The Commission has issued the enclosed Amendment Nos. 39, 37, 48 and 49 for the Dresden Station Units Nos. 2 and 3 and Quad Cities Station Units Nos. 1 and 2, respectively, in response to your requests of September 10, 1974 and May 17, 1976, as supplemented March 21, 1977 and March 13, 1978.

The amendments revise Technical Specifications to provide operating temperature and pressure limits in accordance with Appendix G, 10 CFR Part 50.

DRESDEN STATION UNIT NO. 2

QUAD CITIES STATION UNIT NO. 1

Minimum Temperature Requirements per Appendix G of 10 CFR 50

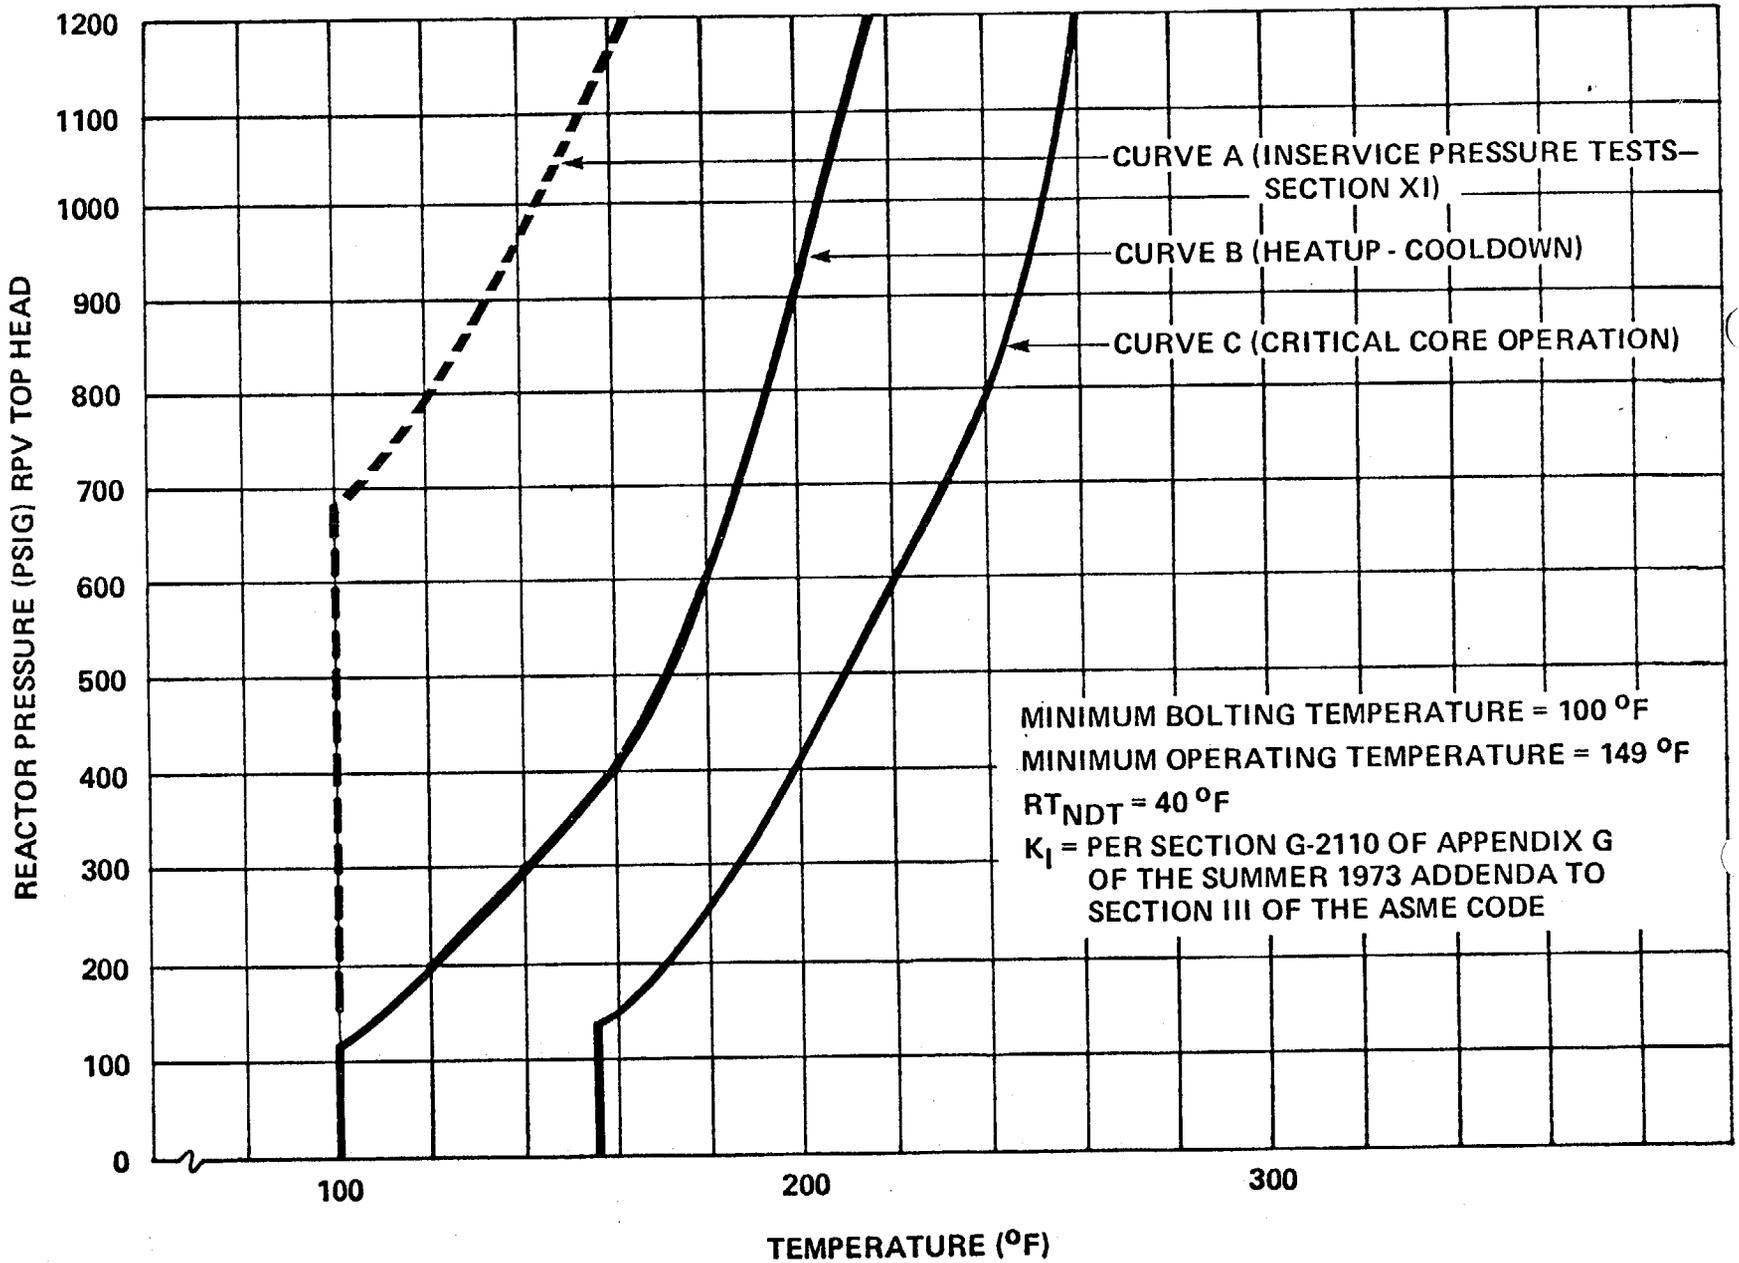
1. The reactor vessel shall be vented and power operation shall not be conducted unless the reactor vessel temperature is equal to or greater than that shown in Curve C of Figure 3.6.1. Operation for hydrostatic or leakage tests, during heatup or cooldown, and with the core critical shall be conducted only when vessel temperature is equal to or above that shown in the appropriate curve of Fig. 3.6.1. Figure 3.6.1 is effective through 6 effective full power years. At least six months prior to 6 effective full power years new curves will be submitted.
2. The reactor vessel head bolting studs shall not be under tension unless the temperature of the vessel shell immediately below the vessel flange is $\geq 100^{\circ}\text{F}$.

Pressurization Temperature - The reactor coolant system is a primary barrier against the release of fission products to the environs. In order to provide assurance that this barrier is maintained at a high degree of integrity, restrictions have been placed on the operating conditions to which it can be subjected. These restrictions on inservice hydrostatic testing, on heatup and cooldown, and on critical core operation shown in Figure 3.6.1, were established to be in conformance with Appendix G to 10 CFR 50.

Minimum Temperature Requirements per Appendix G of 10 CFR 50

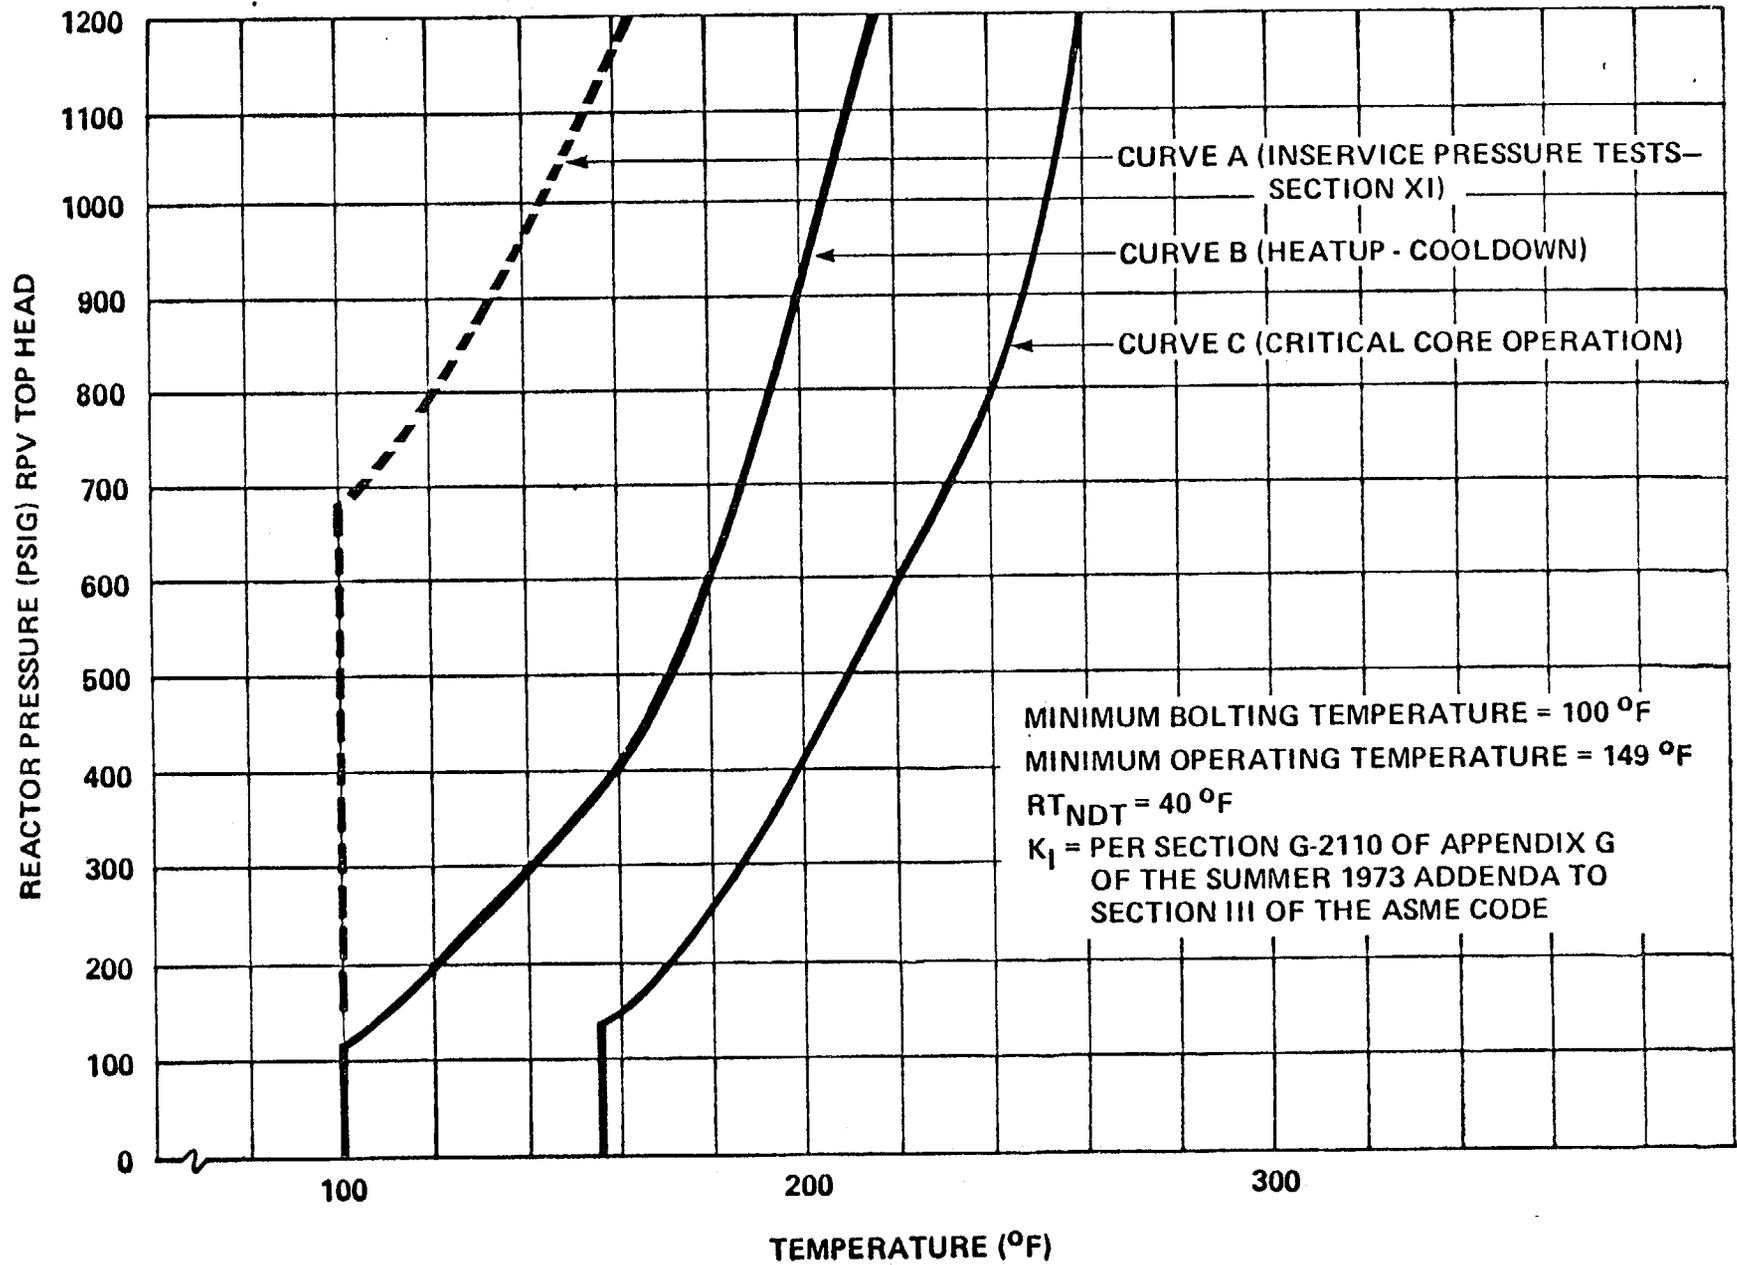
1. The reactor vessel shall be vented and power operation shall not be conducted unless the reactor vessel temperature is equal to or greater than that shown in Curve C of Figure 3.6.1. Operation for hydrostatic or leakage tests, during heatup or cooldown, and with the core critical shall be conducted only when vessel temperature is equal to or above that shown in the appropriate curve of Fig. 3.6.1. Figure 3.6.1 is effective through 6 effective full power years. At least six months prior to 6 effective full power years new curves will be submitted.
2. The reactor vessel head bolting studs shall not be under tension unless the temperature of the vessel shell immediately below the vessel flange is $\geq 100^{\circ}\text{F}$.

Pressurization Temperature - The reactor coolant system is a primary barrier against the release of fission products to the environs. In order to provide assurance that this barrier is maintained at a high degree of integrity, restrictions have been placed on the operating conditions to which it can be subjected. These restrictions on inservice hydrostatic testing, on heatup and cooldown, and on critical core operation shown in Figure 3.6.1, were established to be in conformance with Appendix G to 10 CFR 50.

Fig. 3.6.1

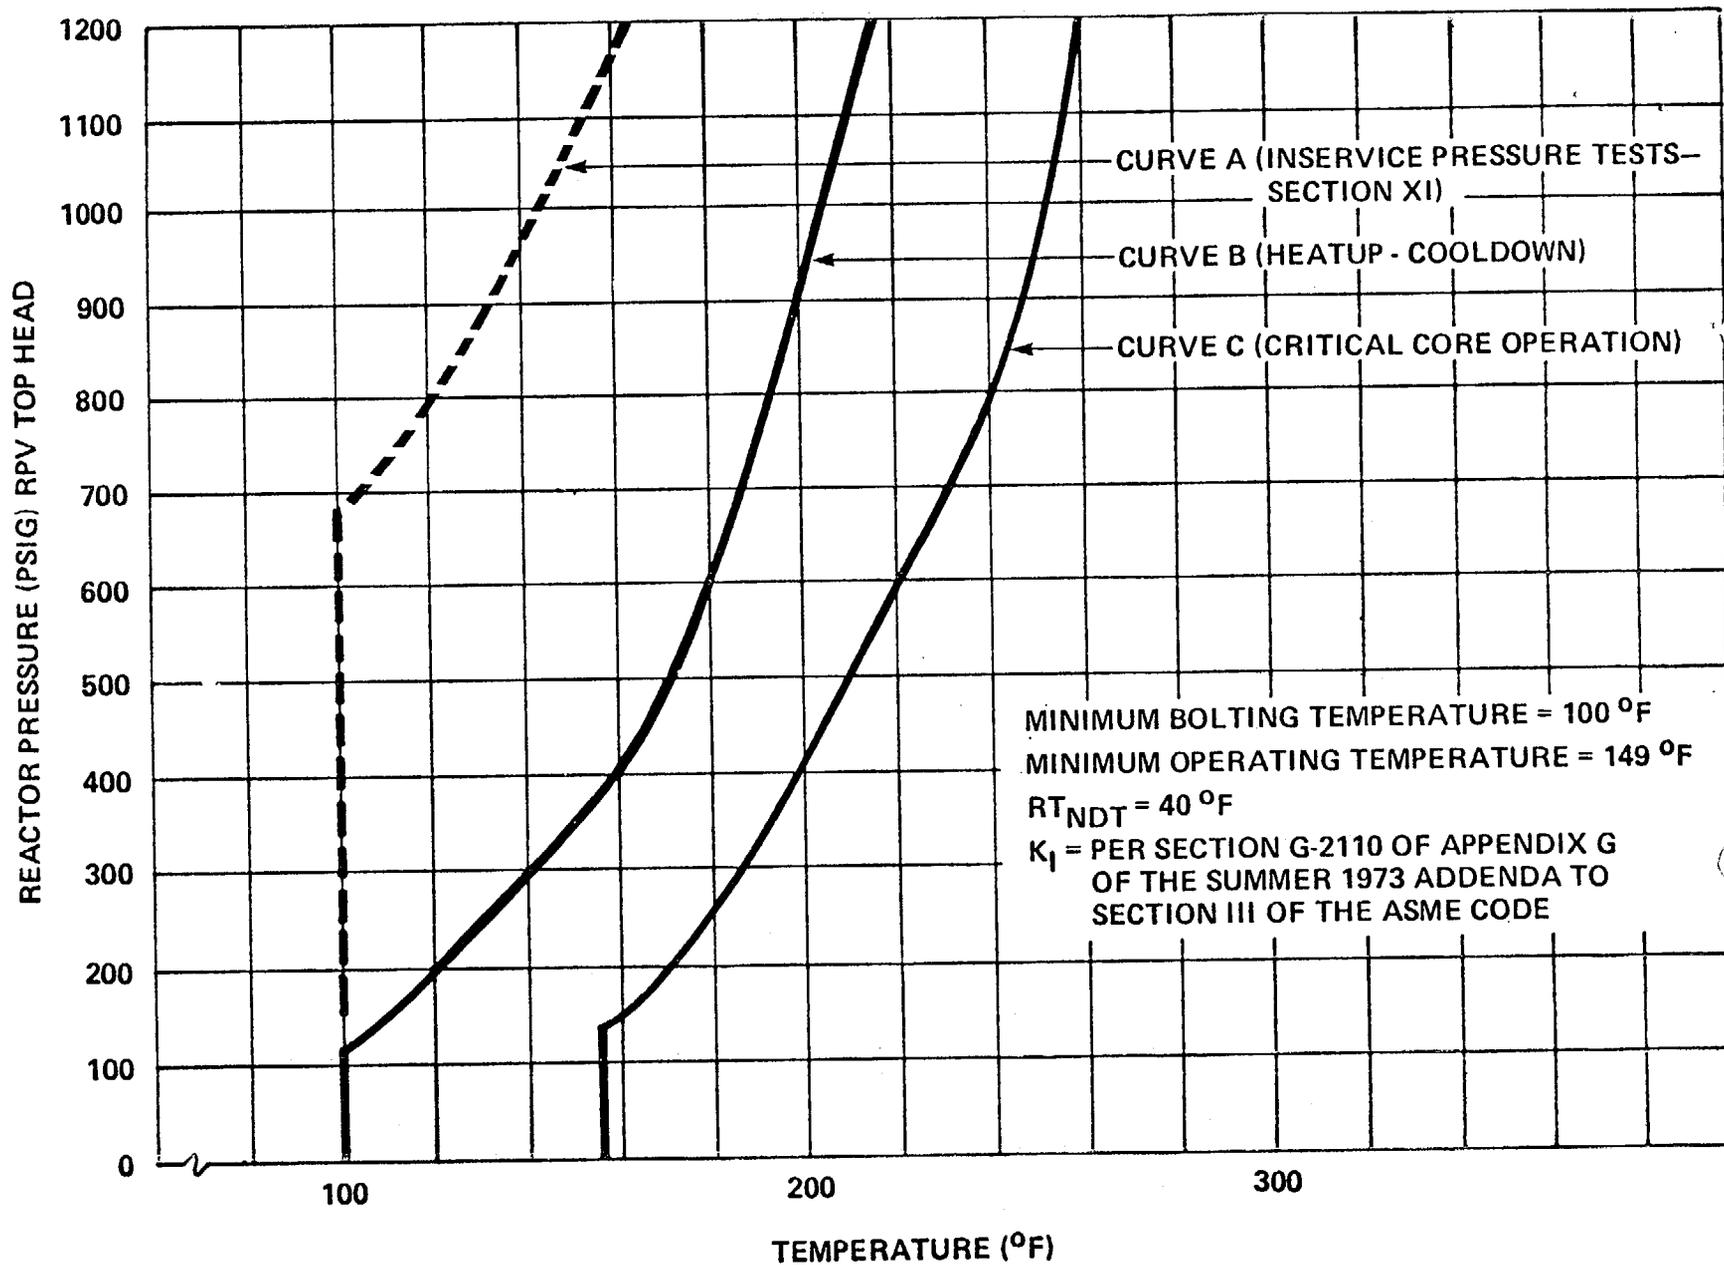
Operation for hydrostatic or leakage tests, during heatup or cooldown, and with the core critical shall be conducted only when vessel temperature is equal to or above that shown in the appropriate curve of Fig. 3.6.1. Figure 3.6.1 is effective through 6 EFY. At least six months prior to 6 EFY new curves will be submitted.

The reactor coolant system is a primary barrier against the release of fission products to the environs. In order to provide assurance that this barrier is maintained at a high degree of integrity, restrictions have been placed on the operating conditions to which it can be subjected. These restrictions on inservice hydrostatic testing, on heatup and cooldown, and on critical core operation, shown in Figure 3.6.1, were established to be in conformance with Appendix G to 10CFR50.

Fig. 3.6.1

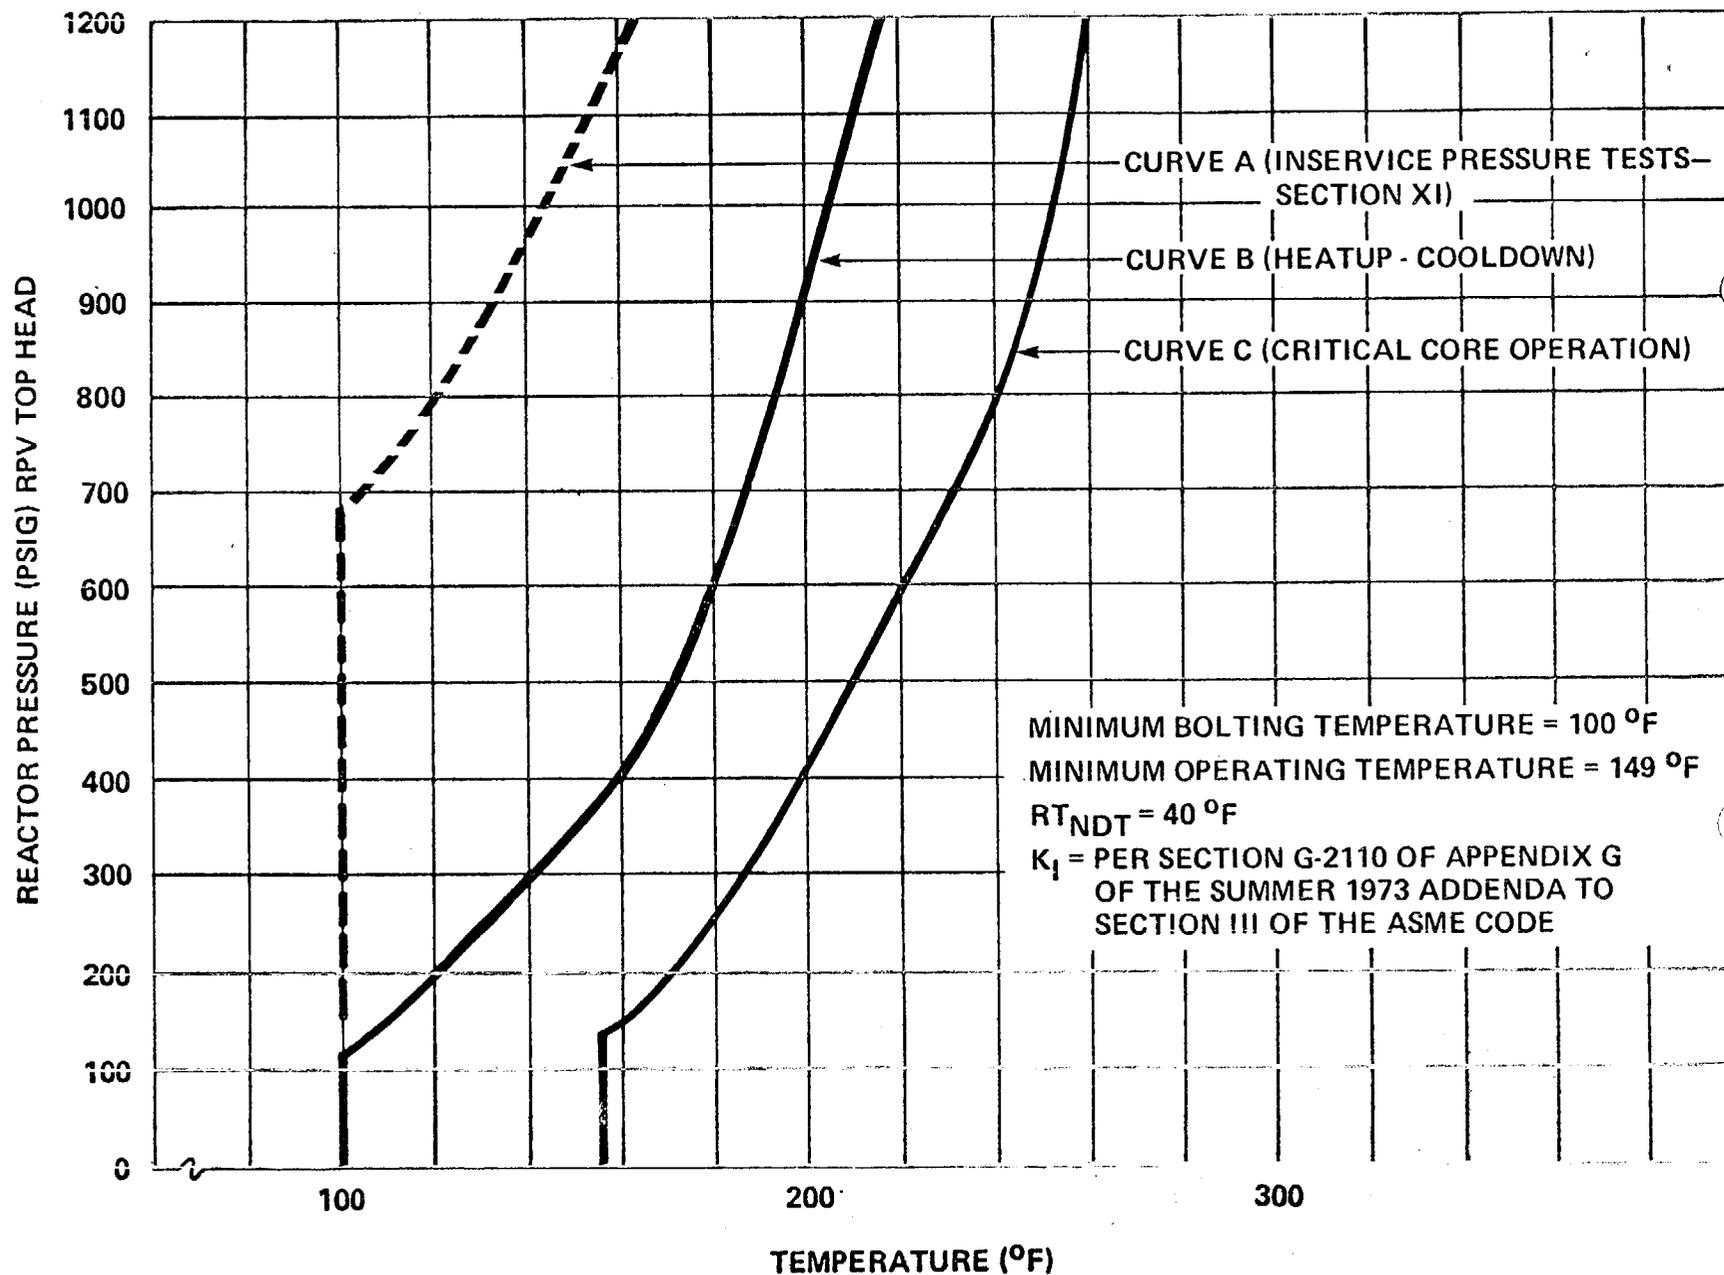
Operation for hydrostatic or leakage tests, during heatup or cooldown, and with the core critical shall be conducted only when vessel temperature is equal to or above that shown in the appropriate curve of Fig. 3.6.1. Figure 3.6.1 is effective through 6 EFPY. At least six months prior to 6 EFPY new curves will be submitted.

The reactor coolant system is a primary barrier against the release of fission products to the environs. In order to provide assurance that this barrier is maintained at a high degree of integrity, restrictions have been placed on the operating conditions to which it can be subjected. These restrictions on inservice hydrostatic testing, on heatup and cooldown, and on critical core operation, shown in Figure 3.6.1, were established to be in conformance with Appendix G to 10CFR50.
